Per Chapter V – National Highway Traffic Safety Administration, Department of Transportation, Part 579 - Reporting of information and communications about potential defect, under 579.5 Notices, bulletins, customer satisfaction campaigns, consumer advisories and other communications, Prevost is submitting an electronic copy of documentations sent to our customers during **the month of February 2016.**

**WB15-55**

DATE :	FEBRUARY 2016	SECTION :	10 - Front axle
EXPIRATION:	FEBRUARY 2018		
SUBJECT :	RADIUS ROD SUPPORT AND I-BEAM AXLE GAP INSPECTION

DATE :	FEBRUARY 2016	SECTION :	14 - Steering
EXPIRATION:	FEBRUARY 2018		
SUBJECT :	STEERING DAMPER SECUREMENT

Figure 2

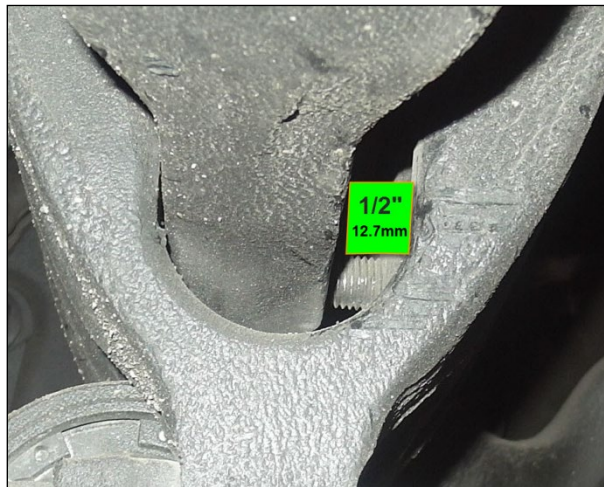
Attempt to insert a shim **12.7 mm** (1/2 in) thick at rear of the axle above the screw between the radial rod support, as shown. (Fig 2.)

**If the shim cannot be inserted** on the left and right support, axle is compliant. *END OF BULLETIN.*

**If the shim can be inserted**, on either one of the supports carry on with next steps.

Figure 3

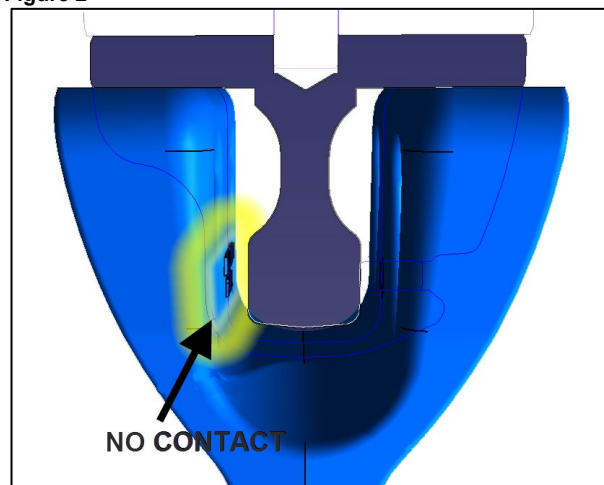
3. Inspect the gap between the axle and the radius rod support on the front.(Fig. 3)
4. After removing debris and protective coating, there must not be contact in zone highlighted in fig. 3.
5. Use a feeler gage set to make sure there is a gap. (Fig.3)

6. If there is contact, skip to **step B.**
7. If there is no contact, remove the set screw in the middle of the support. (A, fig. 4)
8. Replace by a longer set screw, **#5002004** and apply loctite compound **#680038.**
9. Hand-tighten the set screw.
10. Apply a protective coating on affected area. END OF BULLETIN.

Figure 4

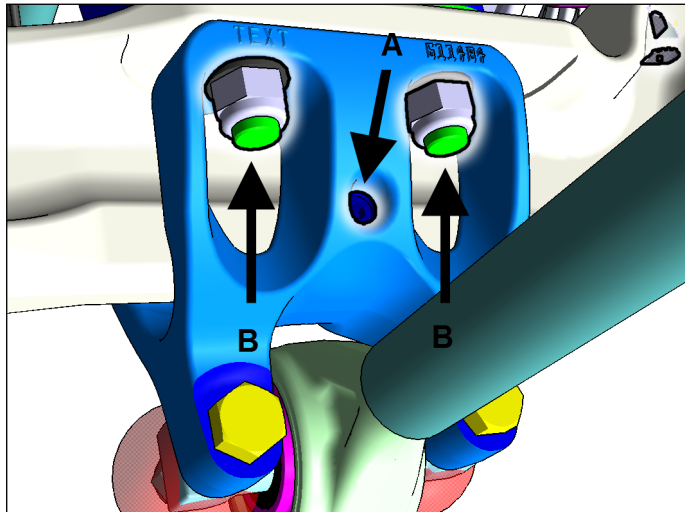
1. Using appropriate protection equipment, clean the end of the screw threads with solvent and brush to remove the protective coating. (B, fig. 4)
2. Loosen by approximately one turn the bracket bolts (4x) (B, fig. 4)
3. Remove the set screw at the center behind the support. (A, fig. 4)

Figure 5

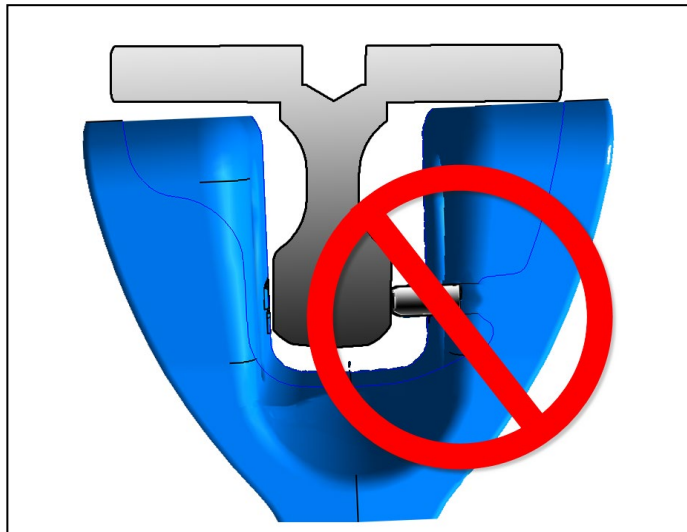
Do not place the support in overhang condition using the set screw as a means to create a gap. (Fig.5)

4. Move the support to try to create a gap. (fig. 3) **Keep the support flat on the axle.**
5. Tighten the bolts and inspect the gap between axle and support.

Use a feeler gage set to confirm there is a gap everywhere. (Fig.3)

Figure 7 Left (Note different hardware arrangement)

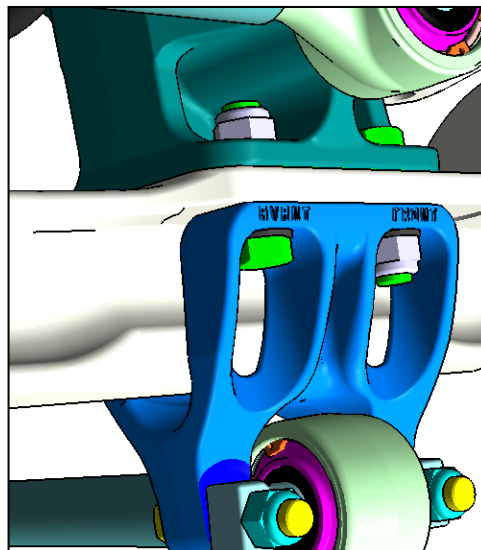
- 6.1. Contact your nearest Prevest Service Center or your Regional Service Manager to plan an axle replacement. Refer to bulletin number WB15-55.
- 6.2. Tighten bolts to **255 lbf-ft**, qty 4
- 6.3. Replace set screw by a longer screw **#5002004** with loctite **#680038**.
- 6.4. Tighten set screw making sure it bears fully on the axle.
- 6.5. Apply underbody protection **#682175** on all affected hardware. END OF BULLETIN.

- 7.1. Tighten bolts to **255 lbf-ft**, qty 4
- 7.2. Replace set screw by a longer screw **#5002004** with loctite **#680038**.
- 7.3. Tighten set screw making sure it bears fully on the axle.
- 7.4. Apply underbody protection **#682175** on all affected hardware.

Figure 1

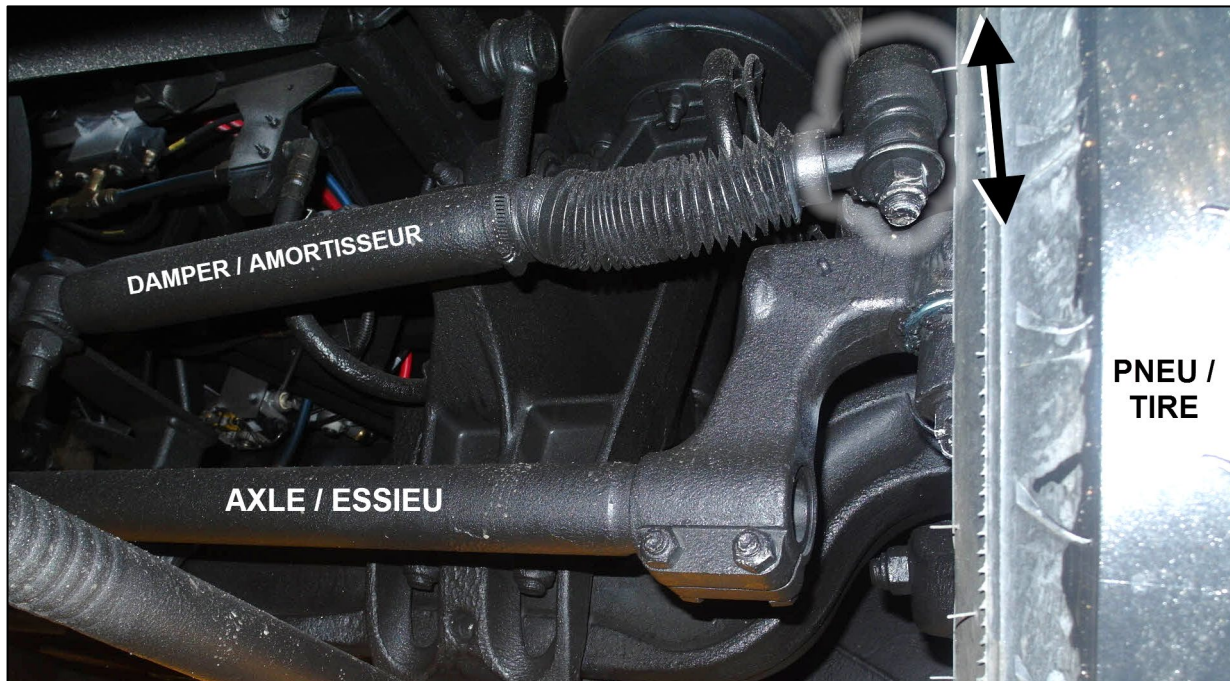
On the vehicles affected by this bulletin the steering damping cylinder rod end spherical bearing may be loose in its housing. Replace as required and secure the steering damper spherical bearing with the provided hardware.

1. Lift vehicle.
2. On front axle the left wheel, locate the steering damper spherical end.(Fig. 1)
3. Make sure there is no vertical play. (Fig. 1)
4. If the spherical bearing moves, replace by a new **660884**.

Figure 2

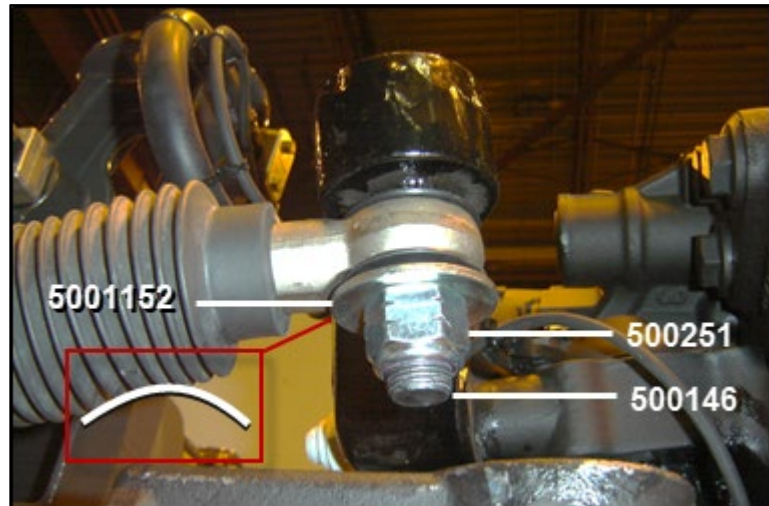
5. Add a washer under the seal é.  
Note washer orientation (fig. 2)  
**5001152** qty 1

Replace le bolt and nut :  
**500146** qty 1  
**500251** qty 1

Tighten to **110** lbf-ft.

Apply corrosion inhibitor on the new parts.
